From: Bouldin Creek Neighborhood Association
To: Mayor Watson and Council Members of Austin City Council
Re: South Central Waterfront combining district

The BCNA membership has reviewed the draft document for the new South Central Waterfront combining district and would like to offer our conditional support of the plan if a few specific requirements can be met.

Relevant maps for lots west of S First.

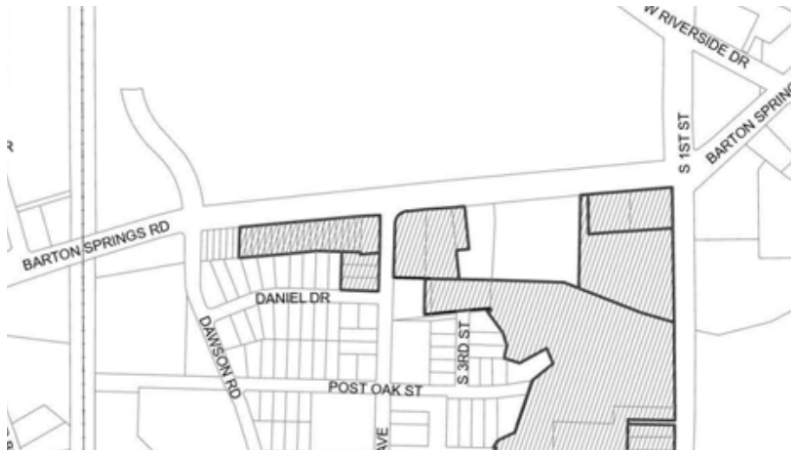
2. We oppose the addition of the 3 lots west of S First, particularly if included in Subdistrict 4 which allows for a FAR of 16:1 and maximum height of 600 ft. We believe this to be inconsistent with the rest of the area immediately to the west of S First St as it would be the only corner allowing this anomalous height. It is also not in line with the soon-to-be-proposed ETOD plan which includes these 3 lots as well as most of the lots west of them along Barton Springs Road and all lots south of them along S. First Street with a maximum height of 120 ft (see next page for maps). We agree with the inclusion of these lots in the ETOD. If there is a strategically beneficial reason for the inclusion of these lots in the SCW, they should be placed in Subdistrict 1 with a maximum height of 120 feet to be consistent with ETOD. To be clear though, ETOD has no maximum FAR, and **we believe that appropriately high densities can be met under the ETOD program by simply excluding this region from the SCW.**

On page 21 of the ETOD document we see the three of the lots west of S First St included, along with most of the rest of the lots along Barton Springs Road and lots on the west side of S. First St., but strangely excluding the 2 lots that already have buildings on them.
(<https://services.austintexas.gov/edims/document.cfm?id=425918>)

On page 20 of the latest SCW document, only 3 lots at the corner are included in the waterfront district.
(<https://publicinput.com/Customer/File/Full/053909e0-14f6-46b4-b107-cc9dcb09c090>)
